## **Disability Access Report**

**Project:** Combined Worship and Community Centre, Offices,  
Cafe  
+ Accommodation

**Address:** 23 Dalcassia Street Hurstville NSW 2220  
**Stage:** Development Application

**For:** The Salvation Army

Figure 1 - screen shot of site plan (Integrated Design Group)

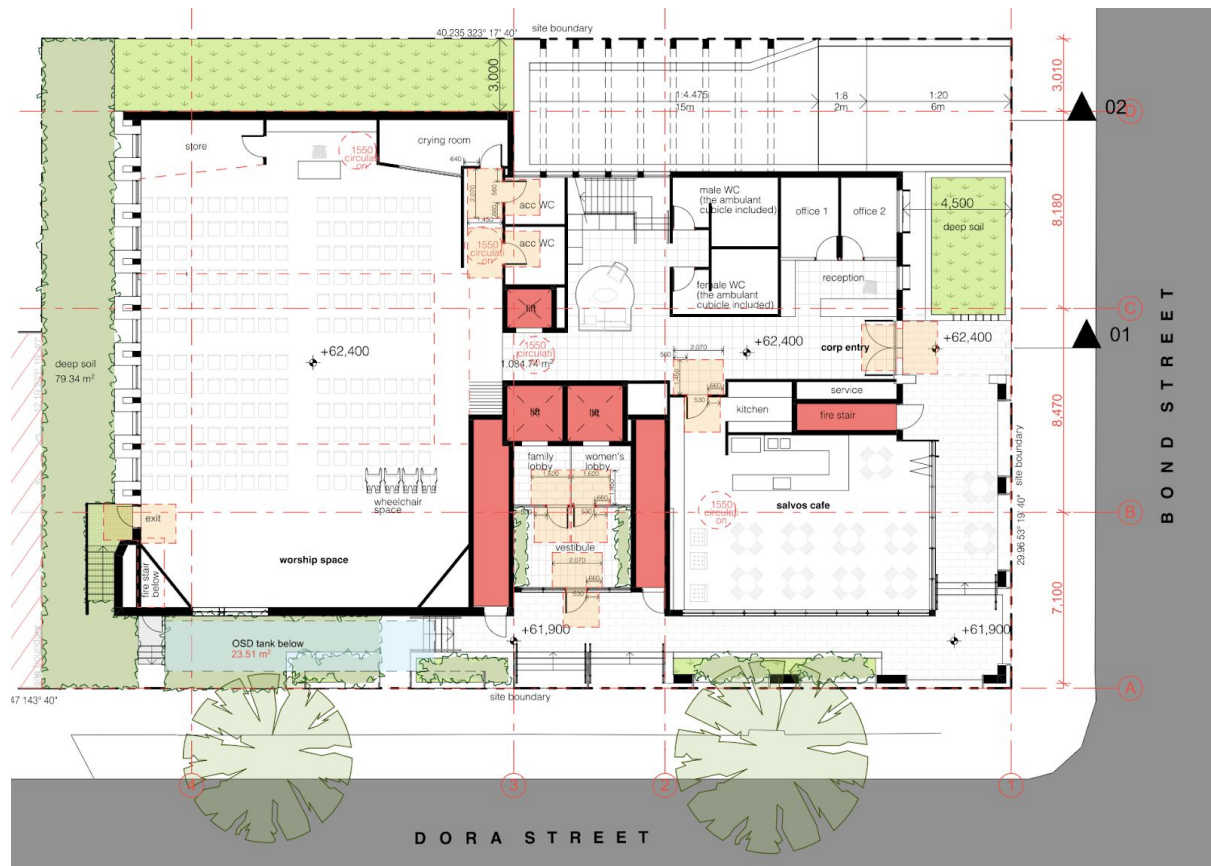
Accessible paths of travel are proposed to be provided from the on-site accessible car parking spaces as well as from the allotment boundary to all pedestrian entrances.

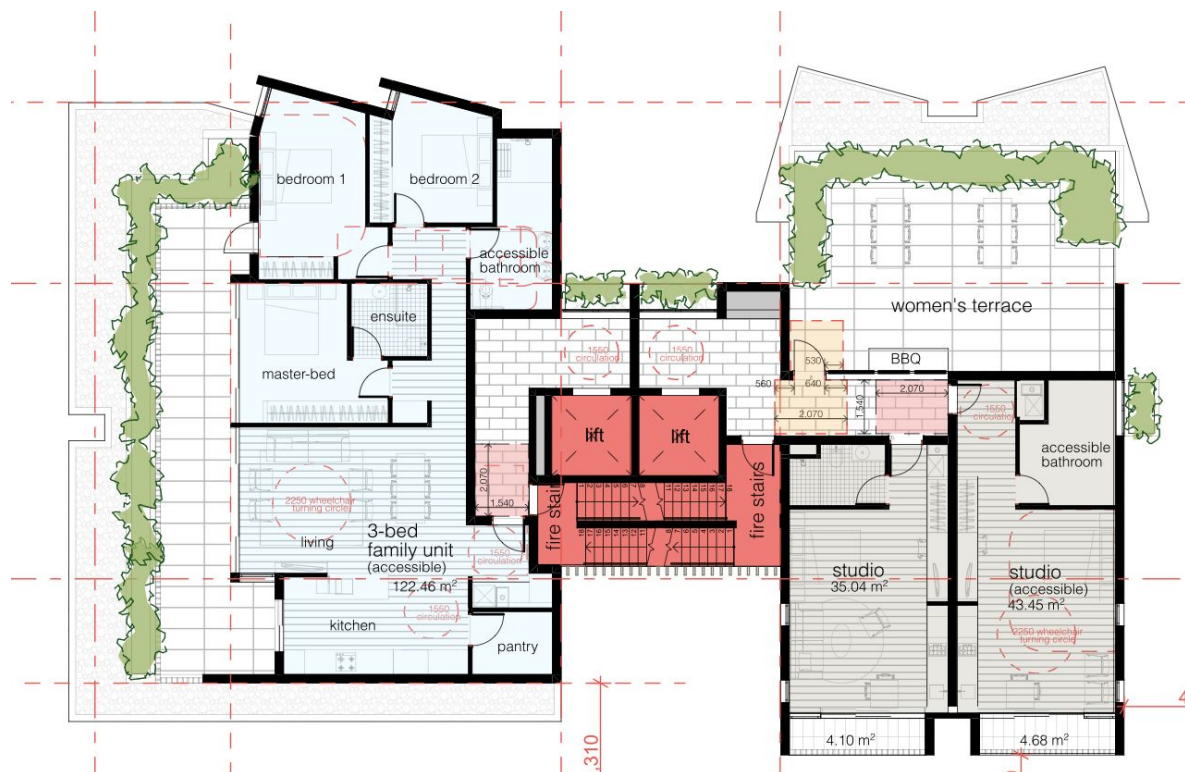
Ensure during ongoing design and construction that the Corps facilities are designed so that it is accessible for a person using a wheelchair as well as people with other types of disabilities.
D3.4 Exemptions	✓	<p>The following is a list of areas within the building which are not required to be accessible:</p> <p>(a) An area where access would be inappropriate because of the particular purpose for which the area is used.</p> <p>(b) An area that would pose a health or safety risk for people with a disability.</p> <p>(c) Any path of travel providing access only to an area exempted by (a) or (b).</p> <p>Exempt areas from access:</p> <ol style="list-style-type: none"> <li>1. Prep kitchen area in cafe</li> <li>2. Plant and services areas in basement and level 7 (rooftop)</li> </ol>
D3.5 Car parking spaces for people with a disability	✓	<p>Parking for the Centre is provided on site across all of the basement levels.</p> <p>A total of 48 car parking bays are shown on the basement level plans including eight (8) accessible spaces with shared zones.</p> <p>This is in accordance with the requirements of BCA 2019 Table D3.5 that requires</p> <ul style="list-style-type: none"> <li>• one (1) accessible carparking space for each 100 carparking spaces for Classes 5 and 9b buildings.</li> <li>• one (1) accessible carparking space for each 50 carparking spaces for Class 6 buildings.</li> <li>• Two (2) accessible carparking spaces for each of the two (2) Class 3 SOUs</li> </ul> <p><u>Recommended Action</u></p> <p>Ensure during ongoing design and construction that:</p> <ol style="list-style-type: none"> <li>1. Parking is provided at required rates</li> <li>2. Parking bay design complies with AS2890.6 including:</li> </ol>

<ul style="list-style-type: none"> <li>a. Parking bay dimensions</li> <li>b. Height clearances on path to accessible parking bay to be a minimum 2200mm (including trees)</li> <li>c. Height clearances at accessible parking bays to be a minimum 2500mm (including trees)</li> <li>d. Gradients and crossfalls to be no greater than 1:40</li> <li>e. Line markings of bays and shared zone</li> <li>f. Provision of bollard in shared zone</li> <li>g. Signage</li> </ul> <p>(AS2890.6 - 2009 Parking facilities for people with disabilities)</p>
D3.6 Signage	✓	<p>Signage schedules were not required for review at this stage of design.</p> <p><u>Recommended Action</u></p> <p>During ongoing design and construction: ensure Braille and tactile signage is provided for</p> <ul style="list-style-type: none"> <li>• Accessible toilet</li> <li>• Areas with hearing augmentation</li> <li>• Directional information where entry is not accessible</li> <li>• Exit level signs</li> </ul>
